UNITED STATES PATENT AND TRADEMARK OFFICE

APPLICATION NO.	FILING DATE	FIRST NAMED INVENTOR	ATTORNEY DOCKET NO.	CONFIRMATION NO.
10/670,499	09/26/2003	Kazuo Shimizu	2003-1274A	8618

Office Action Summary	Applicati n N .	Applicant(s)	
	10/670,499	SHIMIZU ET AL.	
	Examiner	Art Unit	
	Hadi Shakeri	3723

DETAILED ACTION

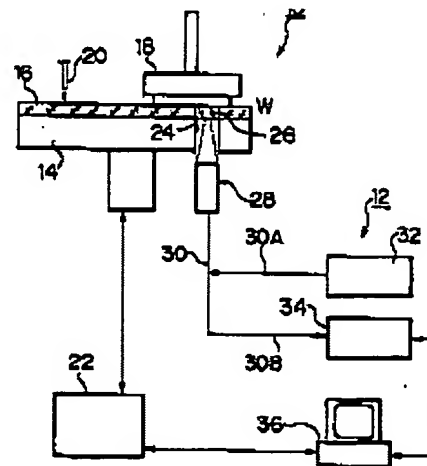
10. Claim 4 is rejected under 35 U.S.C. 112, second paragraph, as being indefinite for failing to particularly point out and distinctly claim the subject matter which applicant regards as the invention.

Regarding claim 4, the language as written, i.e., "...device has a radial length larger than a radius of the workpiece" renders the claim indefinite, for the scope is unascertainable. Firstly the device is recited to include a light source, a spectroscope and a charged coupled device, thus it is unclear what a radial length may comprise, i.e., a length of these components together or of one these component or a combination thereof, and secondly the length is being limited compared to a workpiece. A size of a workpiece is not defined, so the limitation becomes relative without any range or limit set by the claim or the specification as originally filed.

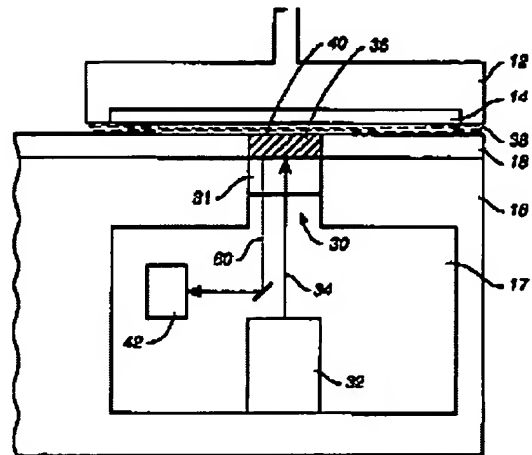
12. Claims 1-5 are rejected under 35 U.S.C. 103(a) as being unpatentable over Yamane et al. (6,511,363) in view of Wiswesser et al. (6,716,085).

Yamane et al. meets all of the limitations of claim 1, i.e., a polishing table (14) having a polishing surface (16); a top ring (18) for holding a workpiece to be polished and pressing the workpiece against said polishing surface on said polishing table; a film thickness measuring device (12), said film thickness measuring

device including, a light source (32) for applying light having a predetermined wavelength to a surface of a workpiece; and spectroscope (34) for separating light reflected from the surface of the workpiece; a charge coupled device array (48) for capturing light separated by said spectroscope; and a controller operable to analyze information captured by said charge coupled device array over an entire surface of the workpiece to obtain a film thickness at a desired point on the surface of the workpiece., except for the film thickness measuring to be embedded in the polishing table.
